STAFF REPORT

Case Number: 2023-MOD-008

Address: 10832 Portside Court (*Approximate Address*)
Location: Lawrence Township, Council District #5

Request: Modification of the development statement for 79-Z-107 (79-DP-3) for

STAFF REPORT 2023-MOD-008, Patio Site Plan

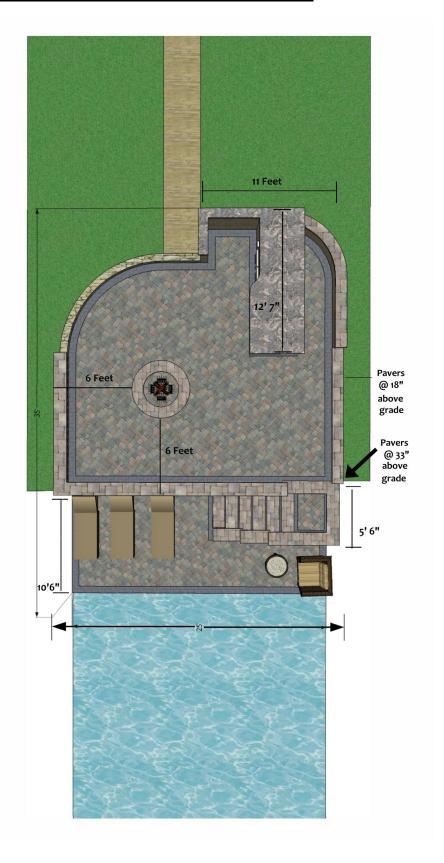
- Materials submitted with this petition indicate that the "panhandle" of the subject property is 25 in width and that the patio area is 25 feet wide.

- Staff understands the desire to provide an area near the water for outdoor entertaining and enjoyment.
- The 25-foot width of the panhandle coupled with the required 22-foot aggregate side yards leave a three-foot wide buildable area. This makes utilization of the panhandle area difficult. Staff believes it would be reasonable to support a reduction in the setbacks that would provide an area near the water for leisure activities.

- However, a structure with zero setbacks is not appropriate. Setbacks provide the vital space that is necessary to construct and maintain any structure. Eliminating that space creates the need to inappropriately trespass onto abutting properties and increases the probability of damaging neighbors' structures and landscaping.

- Decreasing the size of the patio would allow adequate space for outdoor entertaining and enjoyment without trespassing onto the abutting properties and creating a burden for neighboring property owners.

Staff **recommends denial** of this request. If the request was modified to provide for three-foot side setbacks, staff would recommend approval of the request.
